**22 George Street, Leichhardt
Greenland Australia**
Bulk Excavation Plan

2.0 RESPONSES TO SEPP 65 REVIEW

The clarifications and amendments to the previously issued design proposal have been prepared in direct response to the issues raised by Leichhardt Municipal Council and in particular in the correspondence as outlined in the sections as follows:

3.0 RESPONSE TO EMAIL CORRESPONDENCE FROM ADELE COWIE, DATED 20TH AUGUST 2014 REGARDING OVERSHADOWING DIAGRAMS

2.3.1 BUILT FORM OF THE PROPOSAL SHAREWAY

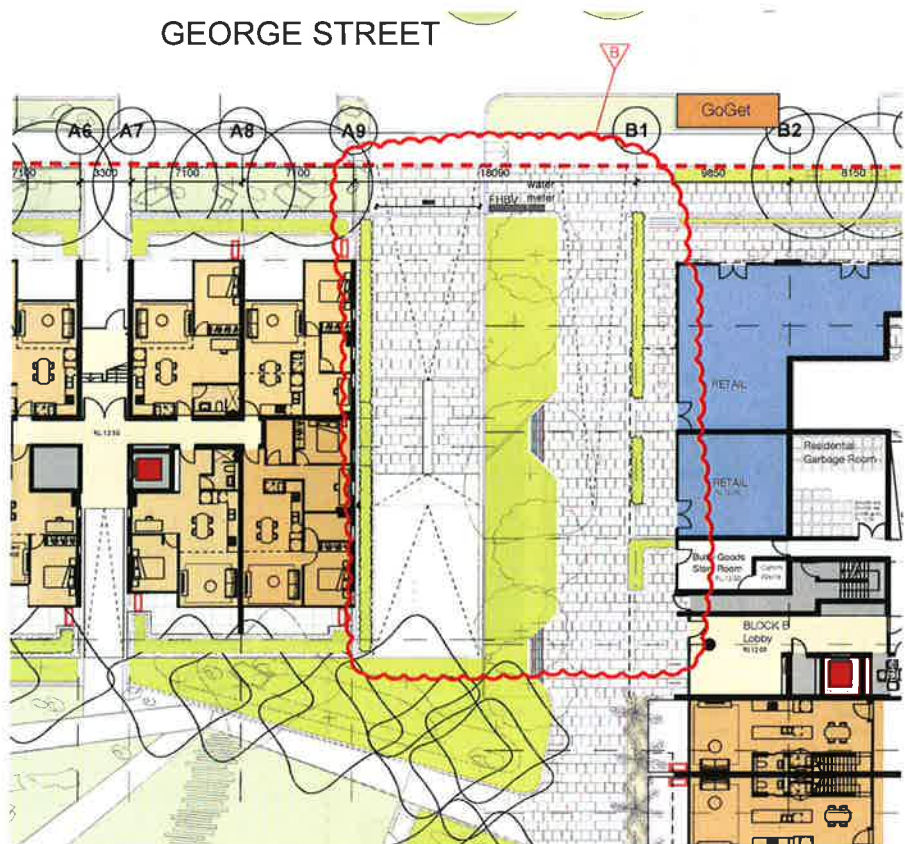
The vehicular access conflict with the pedestrian access and will have safety impacts.

The vehicular access should be directly into and under a building so that visual, safety and amenity impacts are reduced

No parking or drop off should be provided in the pedestrian way.

The proposed development has been amended by repositioning the ramp and straightening the run alongside Block A (with landscape buffer). The cars in the share-way have been relocated to the basement while the share-way has been deleted and is converted to purely a landscaped/ pedestrian zone only.

Please refer to the attached architectural drawings in Appendix A and particular the ground floor plan which has been amended to reflect the above changes.

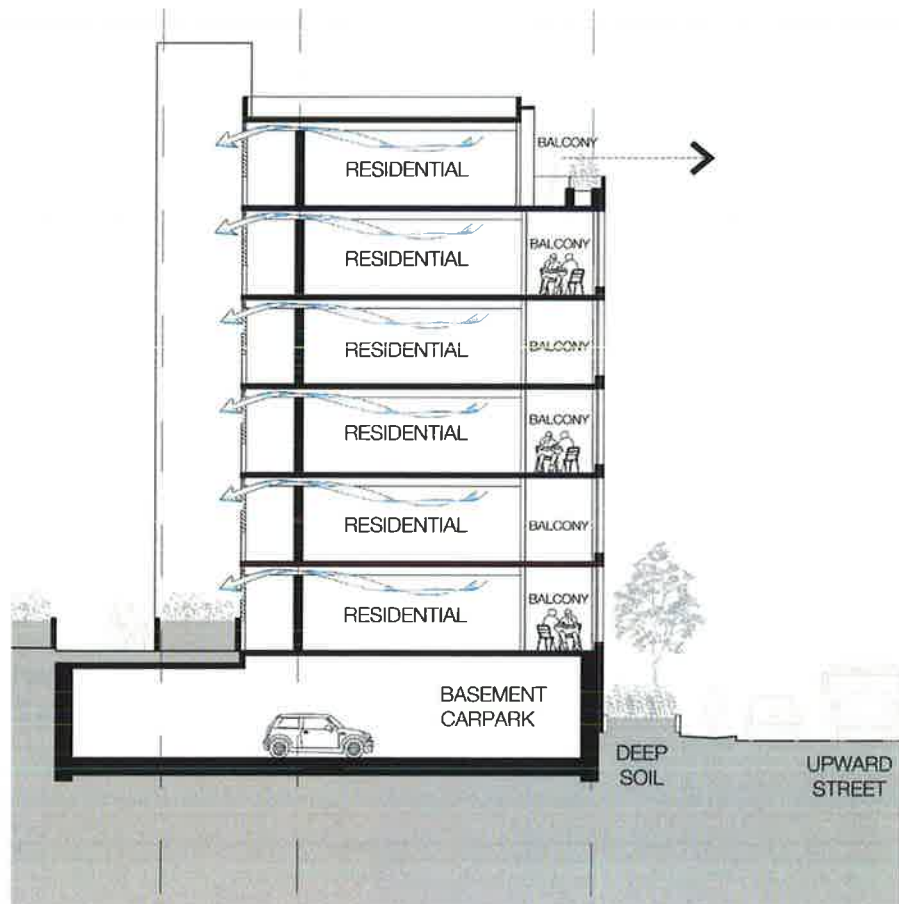
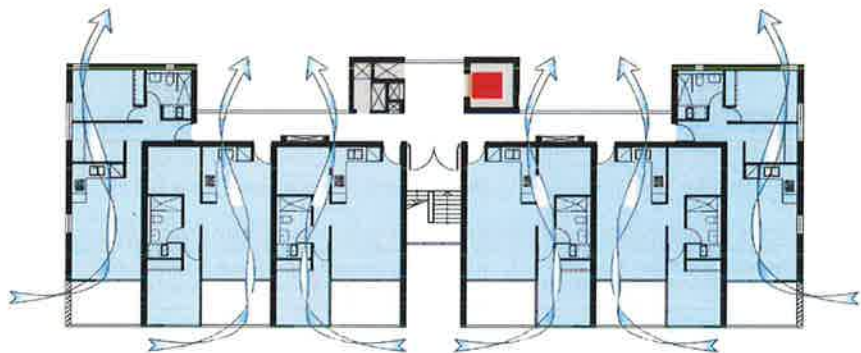
Building C comprises an open single sided corridor with west (street) facing units that appear to conform to the DCP depth. This configuration is considered appropriate however it is important for comfort and liveability that the units be provided with cross ventilation.

/ A section through block C illustrates that with the use of plenums at high level over the corridors we can connect directly into the units and provide cross ventilation to all units at all levels

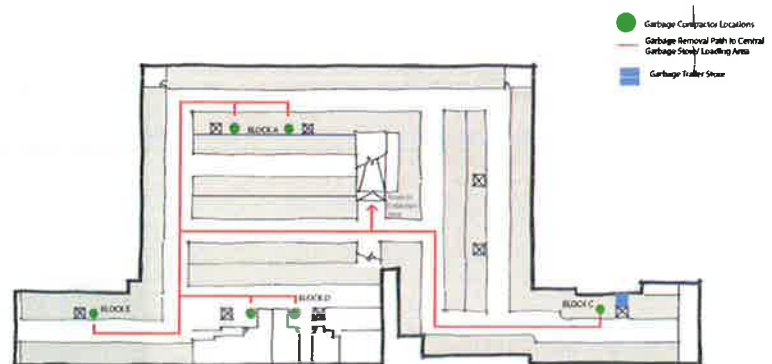
The residential bin collection area must be located within the basement and accessible by a standard garbage truck as per Council's DCP. This will require substantial redesign of the basement. The number of bins shown accommodated is insufficient - refer to DCP 2013 for requirements. Manager to provide detailed response. Any such room location is to be equally accessible from the five buildings. Any building greater than (3) storeys is to be provided with a bin store room on each floor for garbage, food waste and recycling.

/ The proposed development due to its size and complexity results in extremely large waste requirements (both in terms of number of bins, size of collection rooms and vehicular movements required to service it) as such the proposed strategy has been devised with specialist input and proposes both waste shoots and garbage compactors. The waste shoots centralises the garbage collection for each building core and removes the need for residents moving the bins themselves, while the garbage compactor effectively halves the amount of bins and therefore amount of time required for collection.

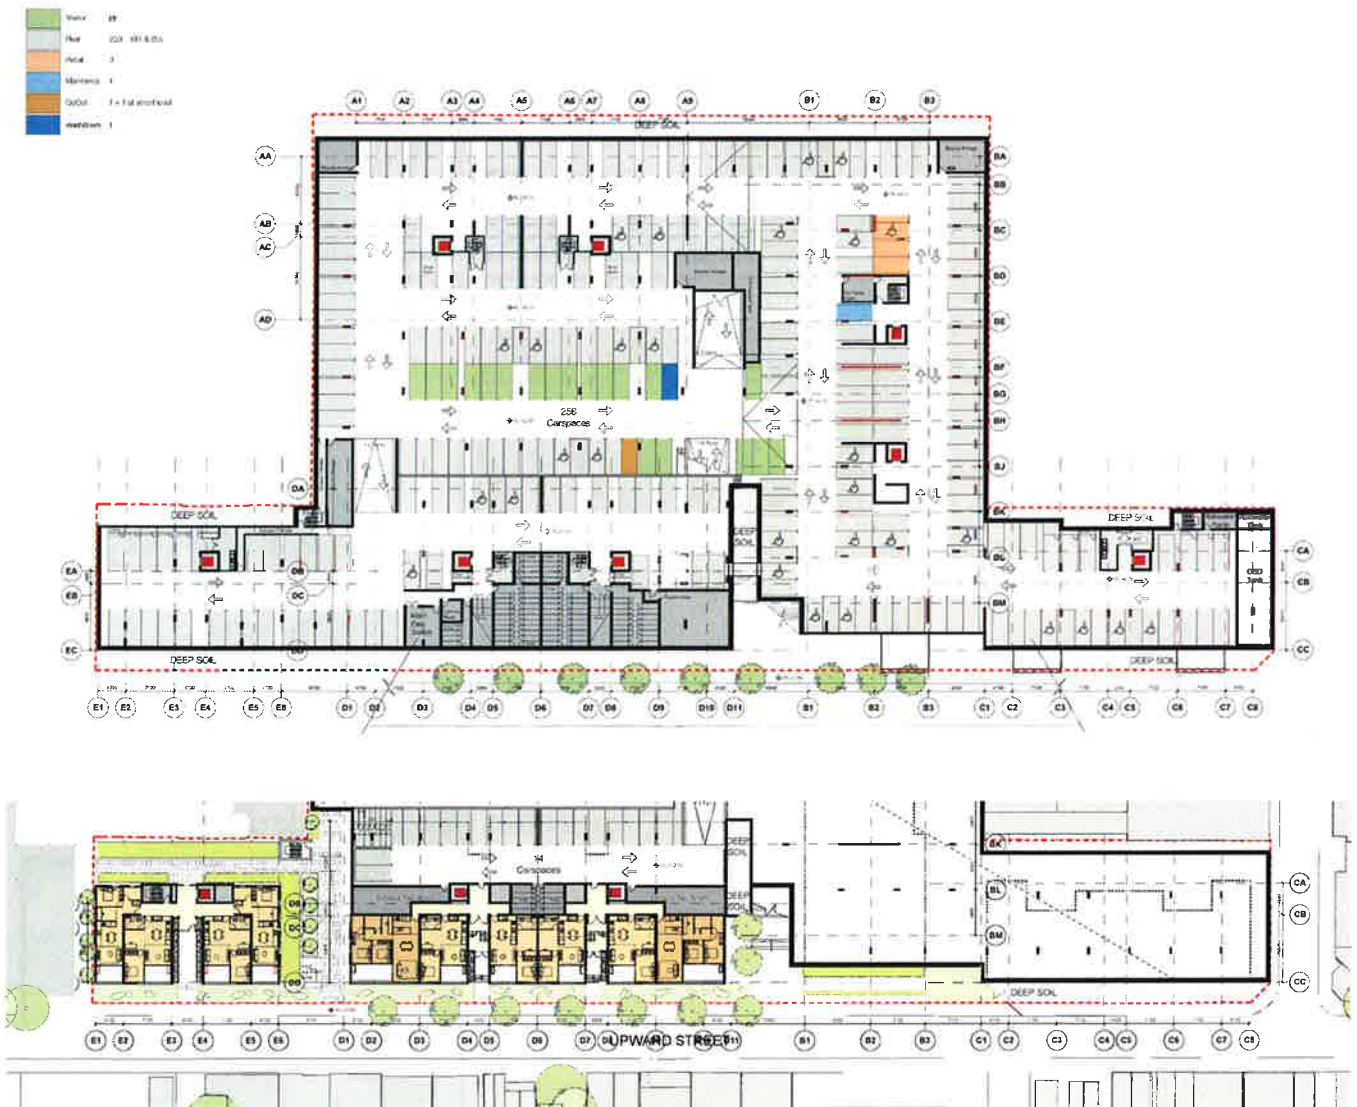
Allocation of retail, visitor, and resident spaces to be indicated on plans.

Allocation of retail, visitor and residential spaces has been illustrated on basement and lower ground floor drawings

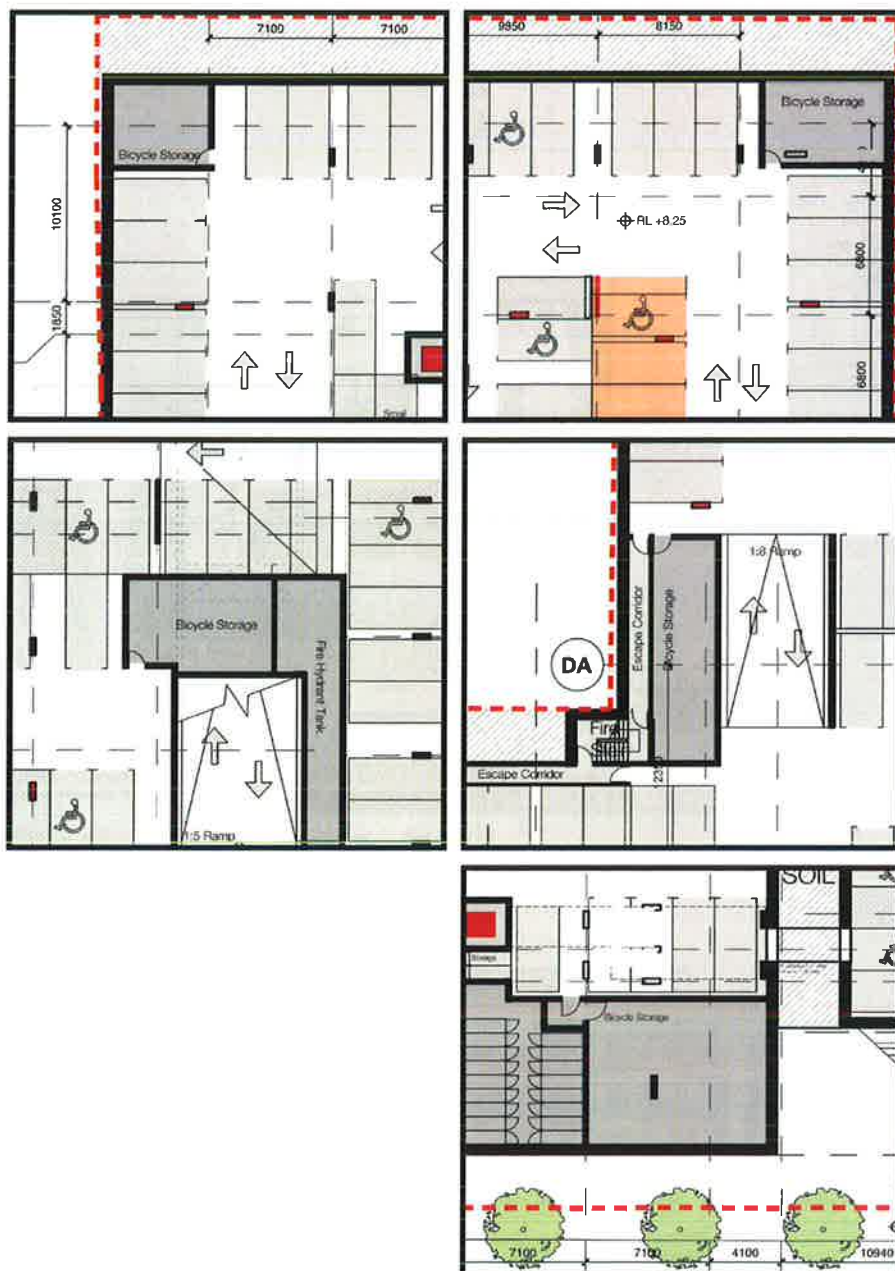
Some bicycle storage areas within the basement cannot be accessed due to the location of car parking spaces nearby.

/ Bicycle stores locations have been amended to provide adequate access between the entry door and the adjacent parking bay

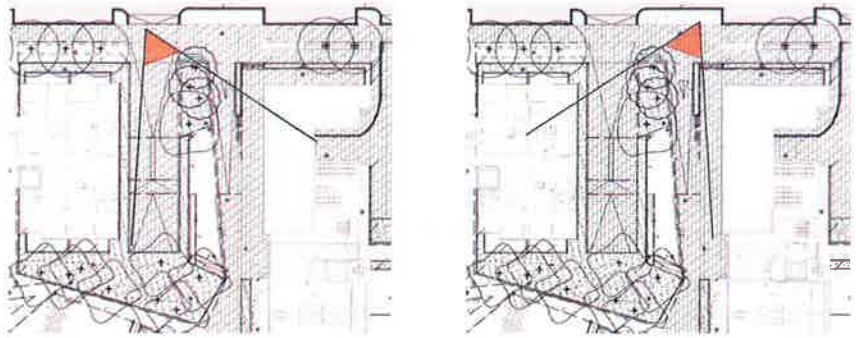
A centralised removalist bay must also be accommodated within the basement

/ A centralised removalist bay has been provided at ground floor at the southern boundary of the site, with separate driveway accessed from George Street. The removalist bay has been separated from the basement to avoid conflict between trucks, cars and pedestrians.
